Introduction/Summary

TO: Urban Design Commission
FROM: Lisie Kitchel, Bay Creek Neighborhood
DATE: June 26, 2020
SUBJECT: 113 Lakeside St. (VFW site) Proposed Development

Re: 133 E. Lakeside St. Item # 60406

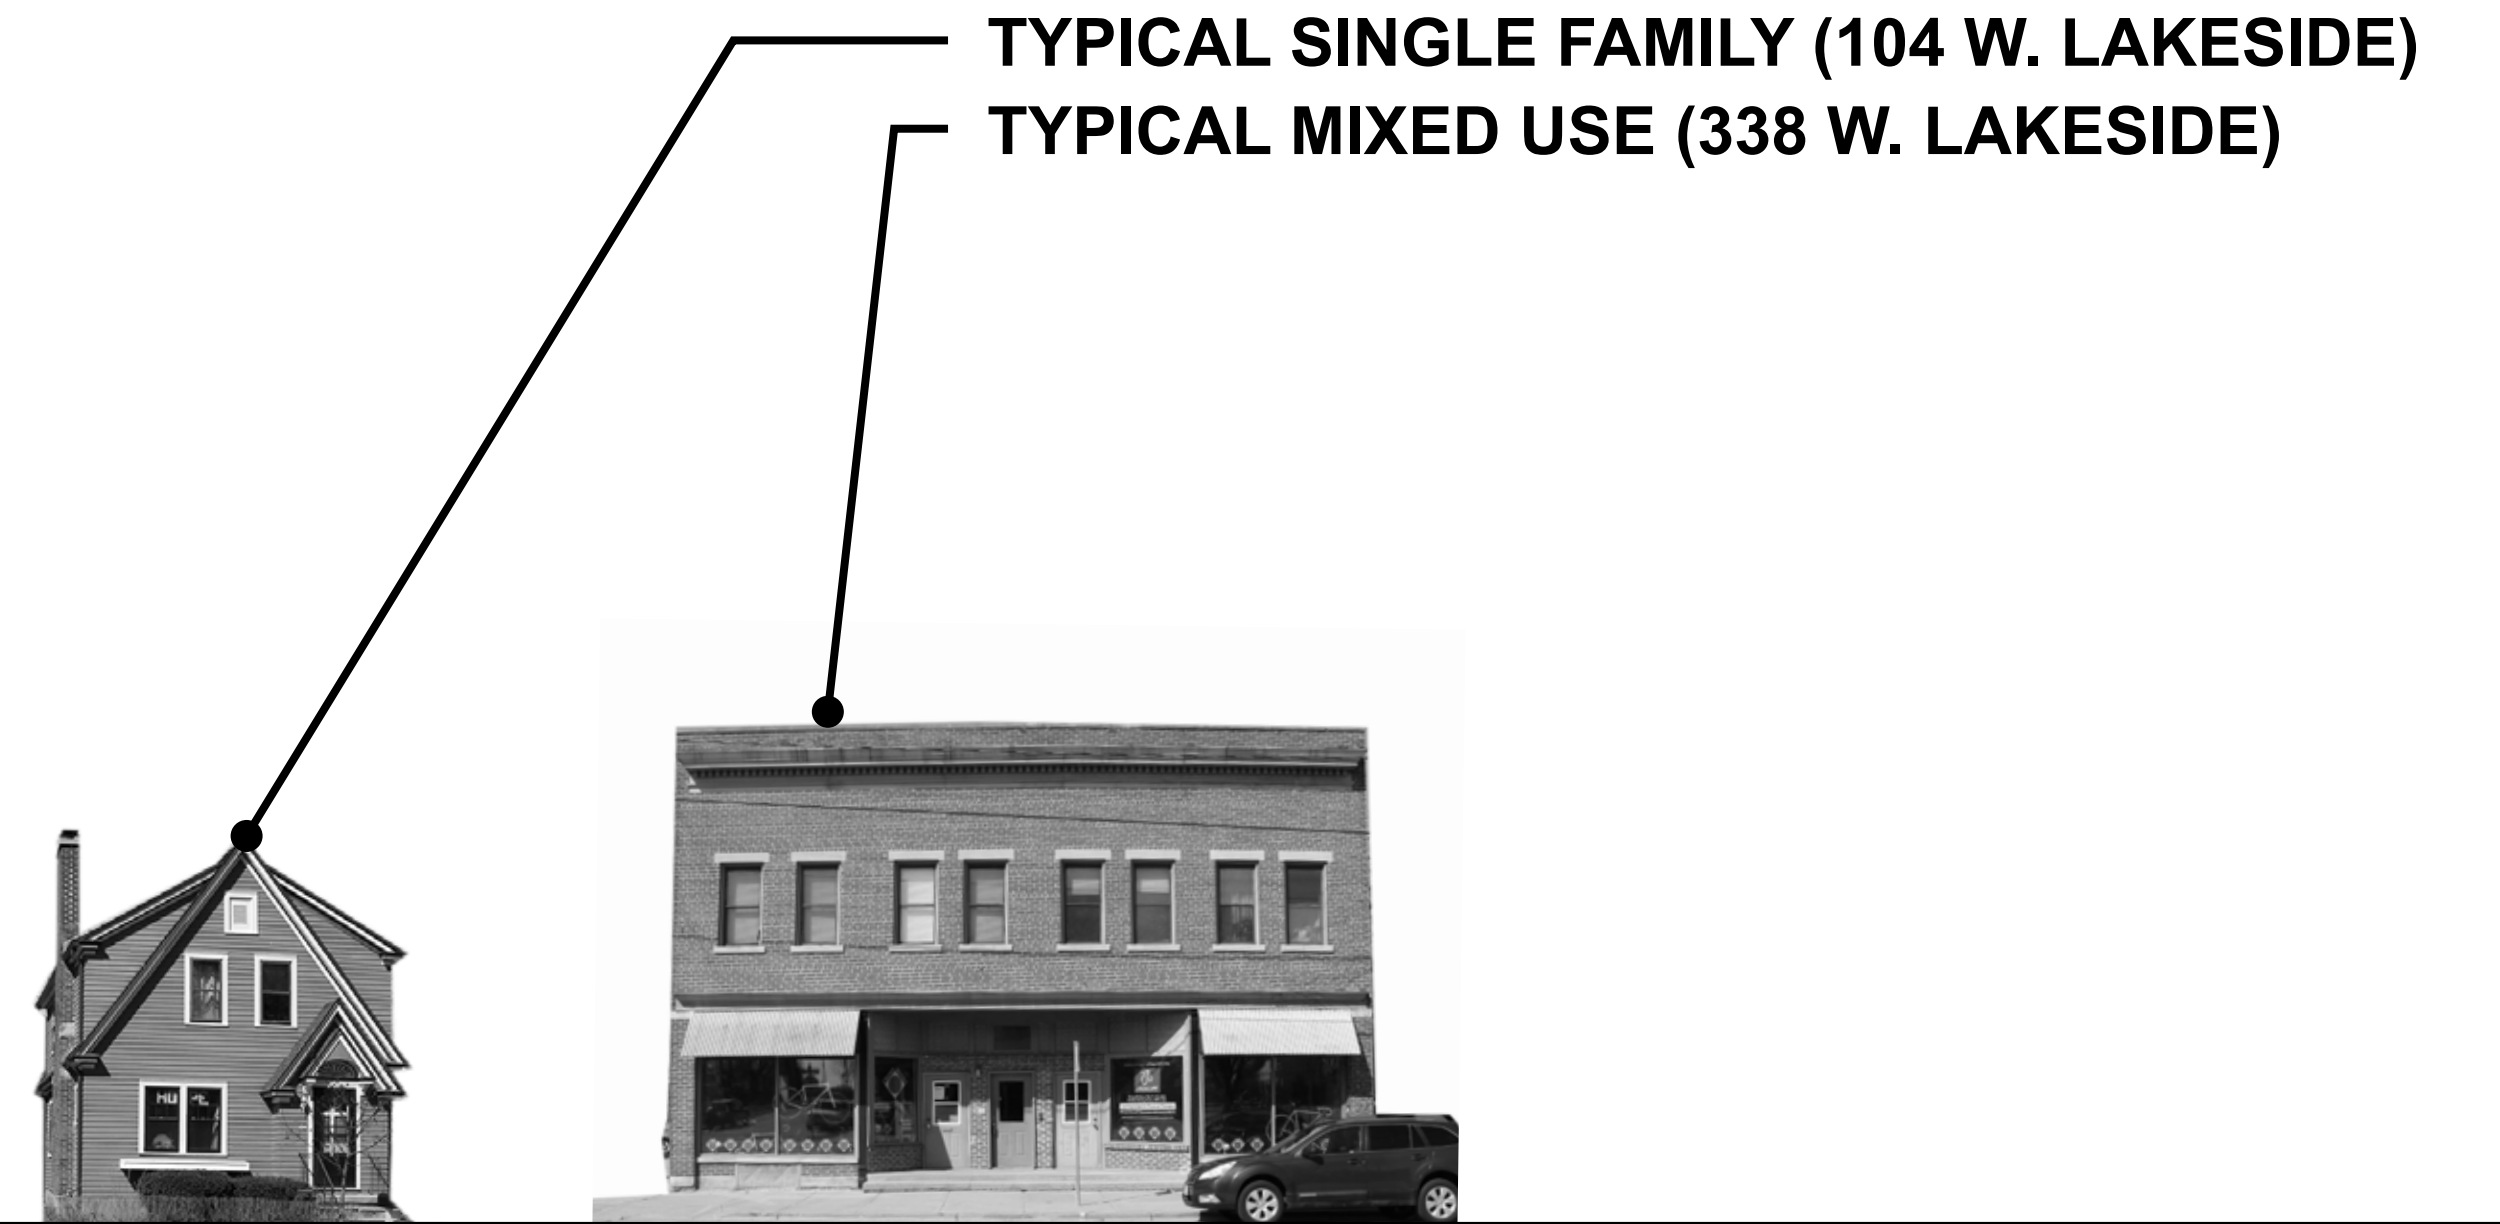
- 2) The scale and design of the building may fit with the John Nolen corridor further east, but its size and its materials are out of place viewed from the surrounding community.

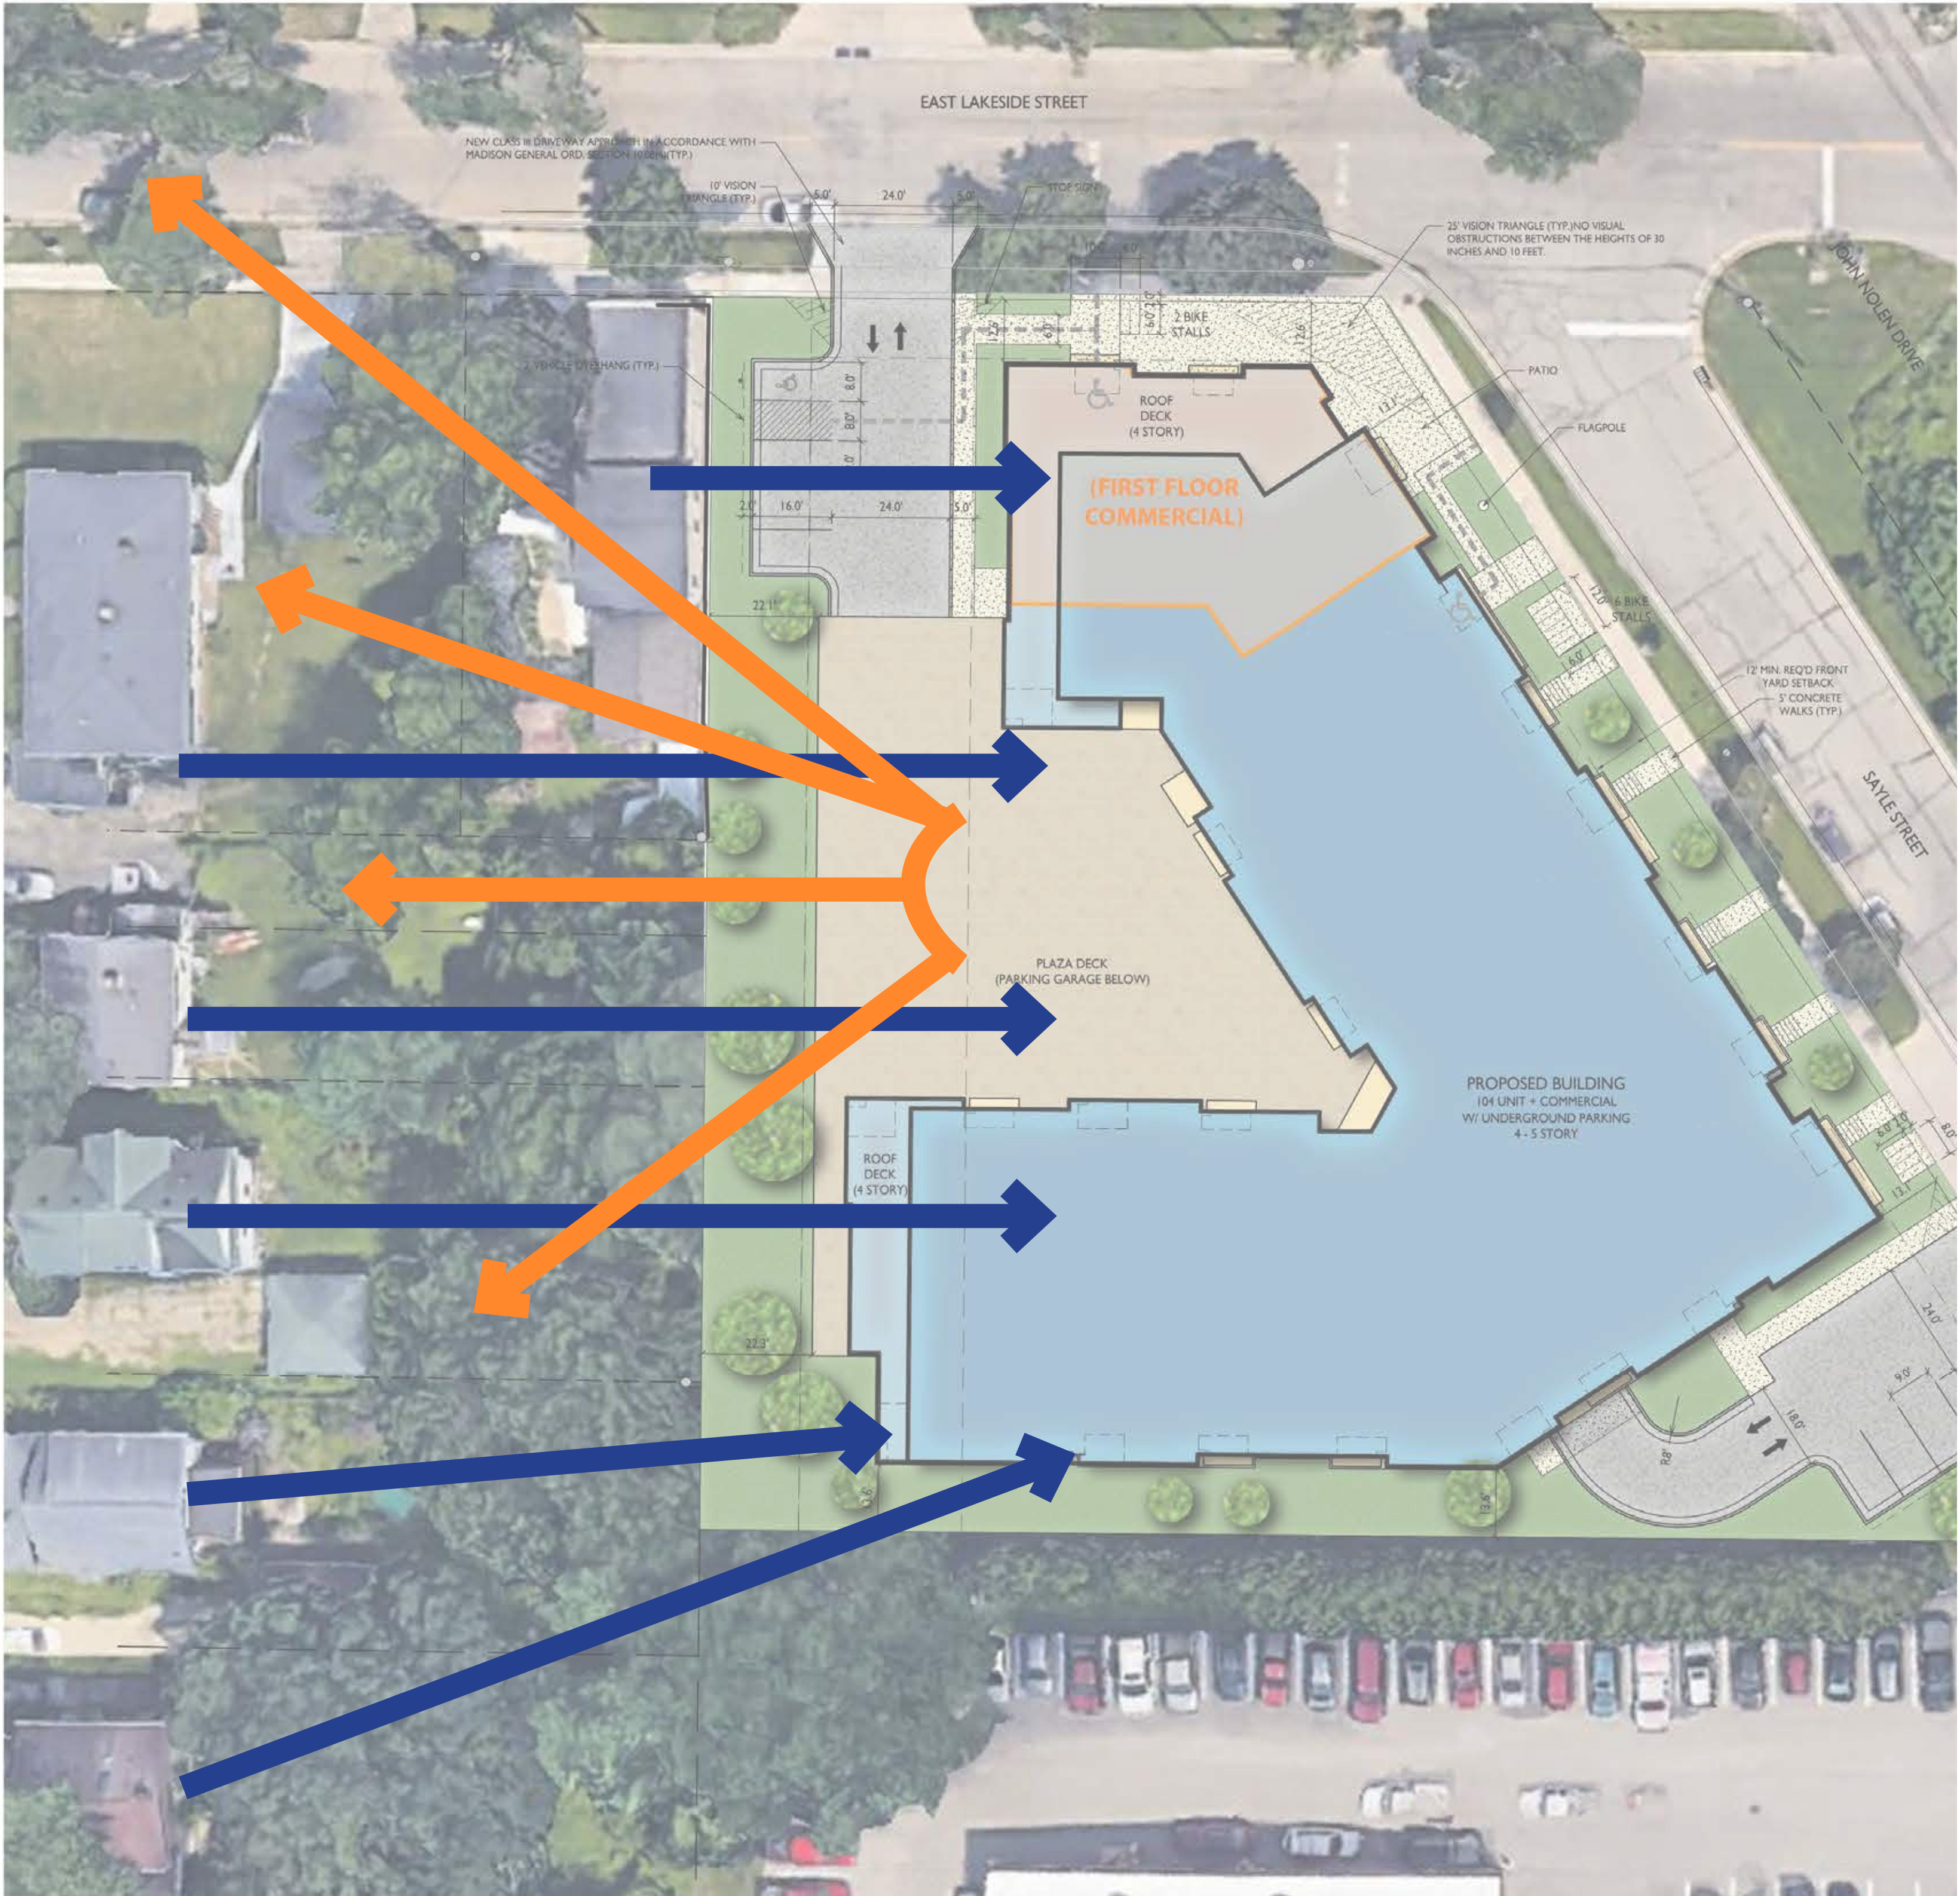
PROPOSED FOOTPRINT IS
APPROXIMATELY 60 TIMES
LARGER THAN THE AVERAGE
SINGLE FAMILY HOME IN THE
NEIGHBORHOOD

LARGER THAN THE EXISTING
ELEMENTARY SCHOOL

- VIEWS SHALL BE RENDERED IN WINTER AND SUMMER
- SECTIONS SHALL BE PROVIDED AT ALL VIEWS FROM ADJACENT PROPERTY ON COLBY STREET AND INCLUDE DIFFERENCE IN ELEVATION BETWEEN PROPOSED DEVELOPMENT AND EXISTING HOMES AND LOT LINES.

IMAGE 1: SAYLE AND E. LAKESIDE

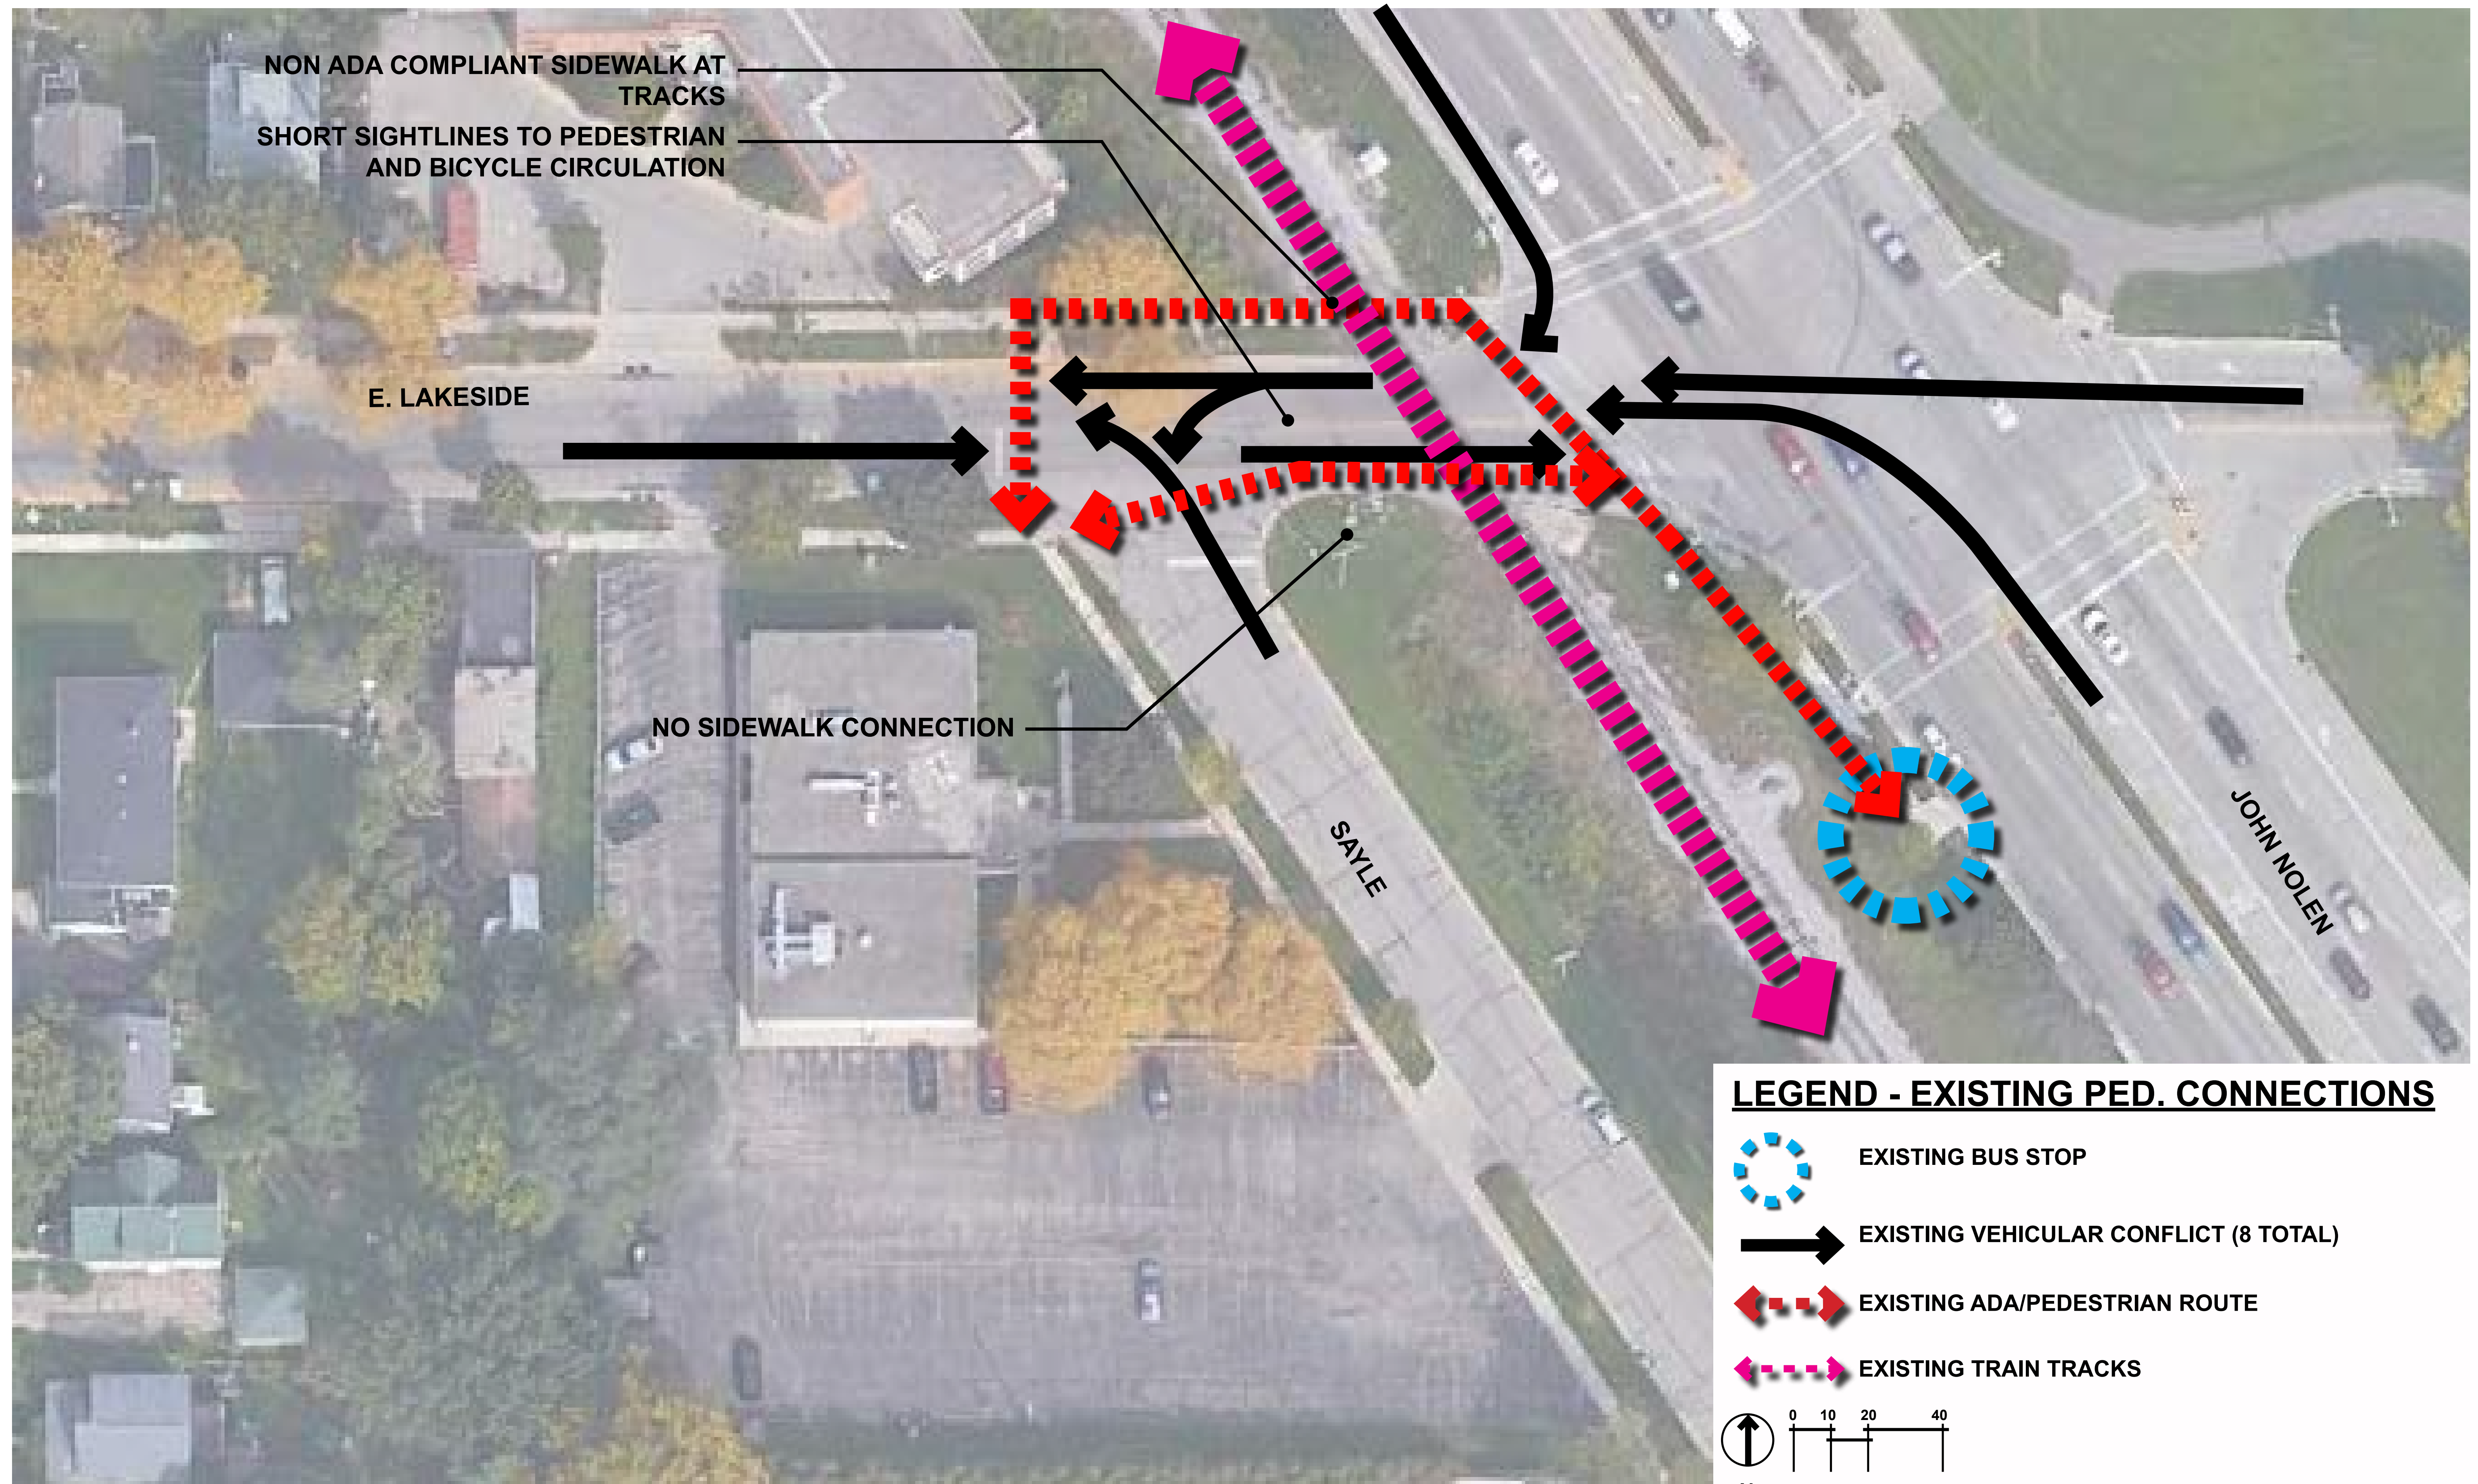
- 1) Traffic congestion and pedestrian crossing at Lakeside/Sayle intersection – Plans to modify this challenging intersection are needed to manage turns into and out of Sayle, pedestrians crossing to the bus stop, and the lack of sidewalk from Sayle east to the bus stop.
